Corrective Action to address FOX defects / DELPHI

**Minor Change: Layout Change to Mitigate Risk from
Defects in Bond Pads.**

TGATE Mask Change Proposal.

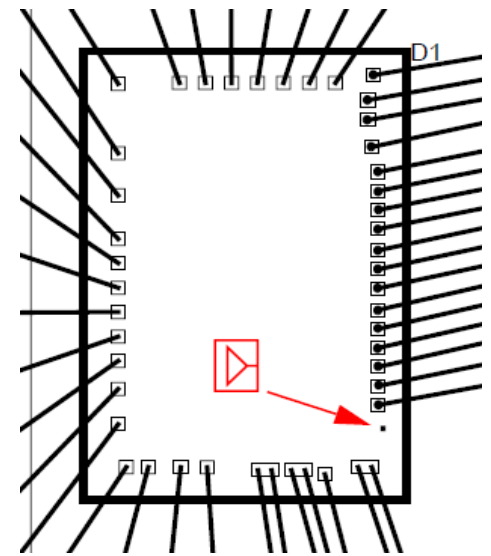
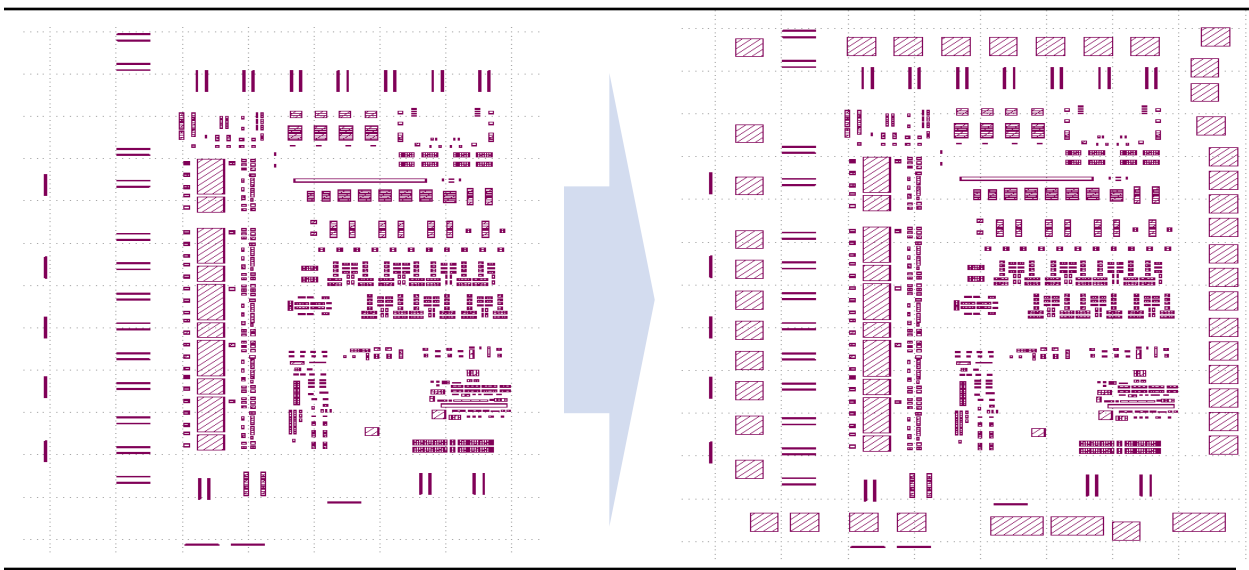
- ◆ ADI addressing root cause of occurrence via defect mitigation, error proofing .
- ◆ This involves an ability to ensure that tox. in the defect area is > 800 ang. vs. 135 ang. minimum currently .
- ◆ The change would apply to area under the bond pad only.

TGATE Mask Change

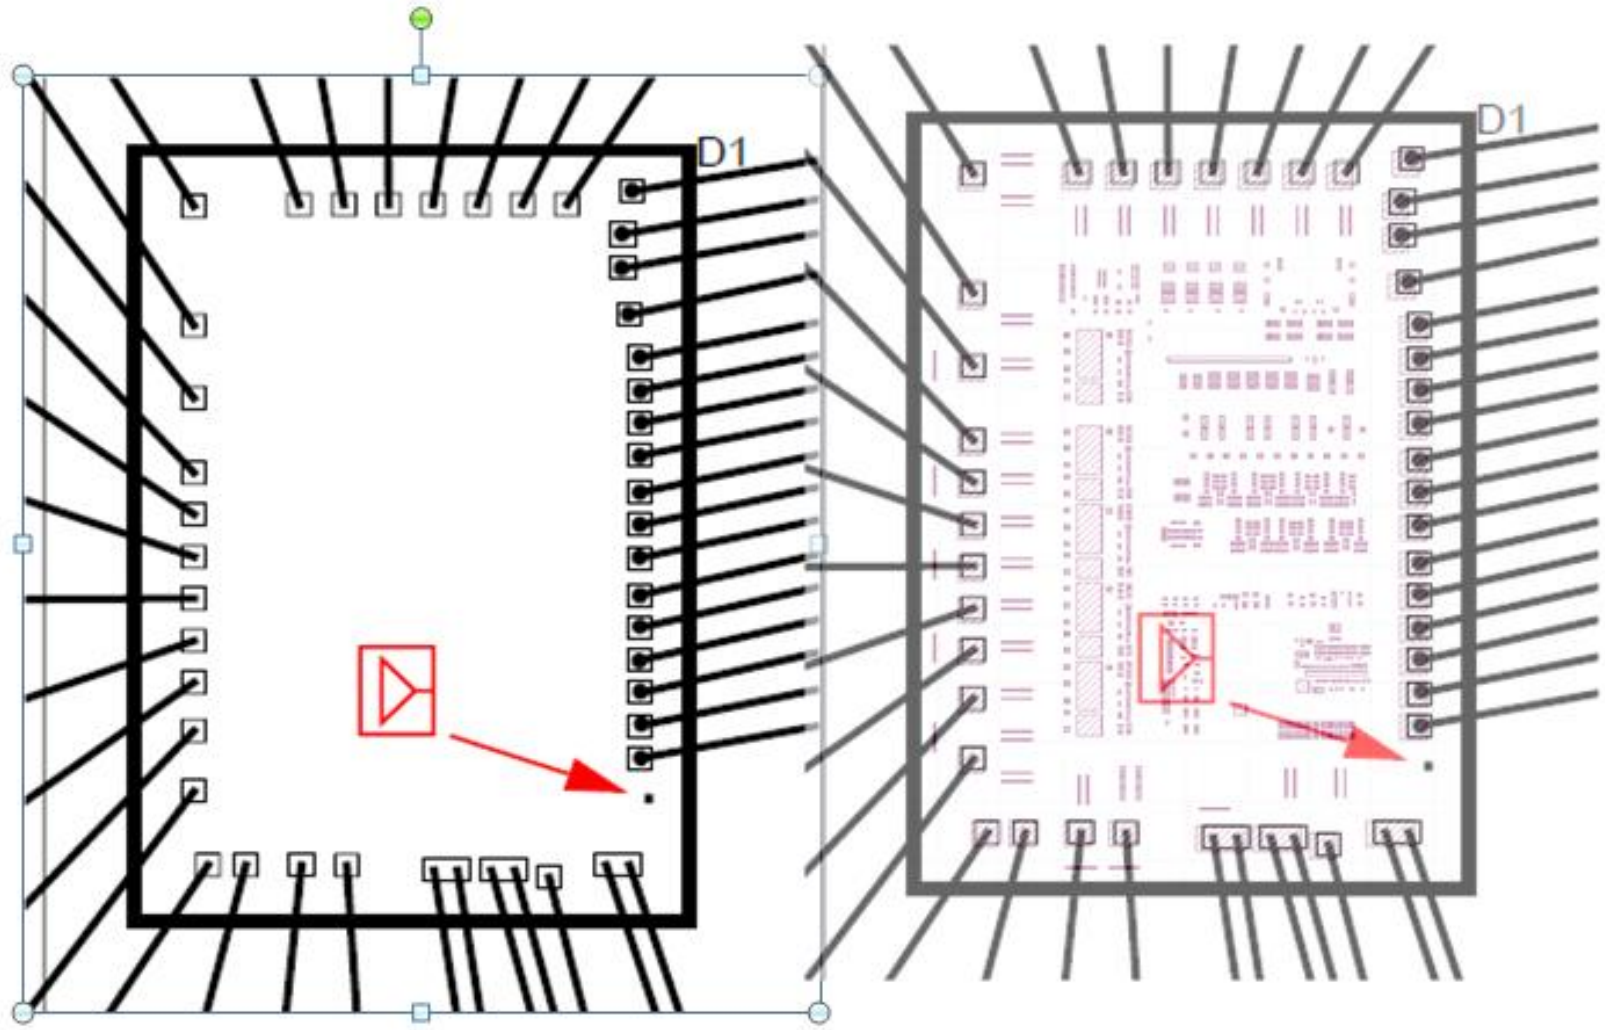
TGATE mask defines areas of thick gate oxide for high voltage devices on the process. The proposal involves changing this mask to include the bond pad areas without making any other in circuit changes.

Changes in Tox in Bond Pad Structure

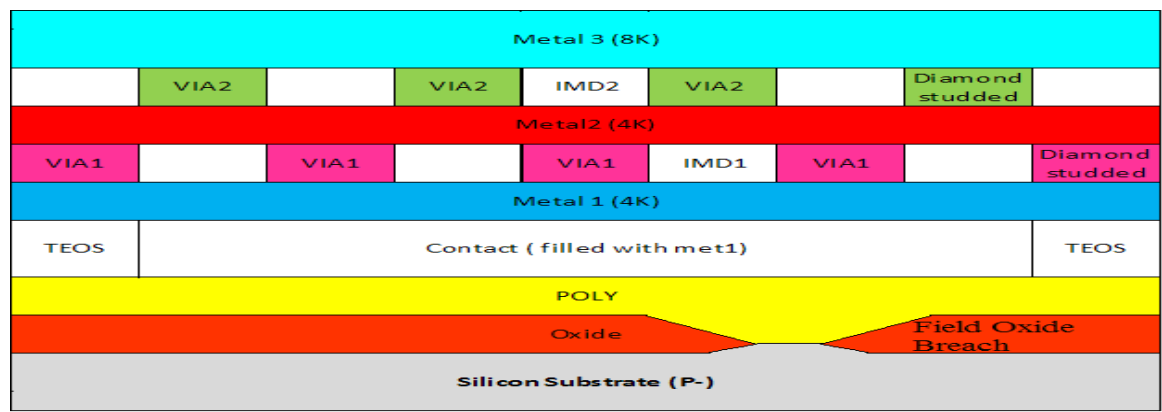
End of Line Field Oxide in bond pad region will thicken up to ~3700ang from ~2800

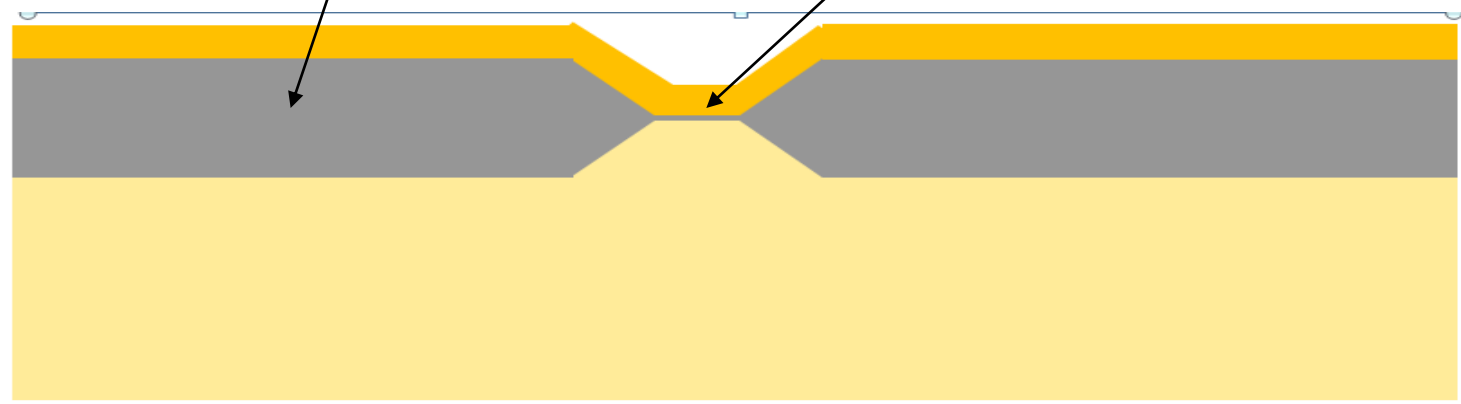
Defect Tox thickens up to ~820ang From ~135ang.
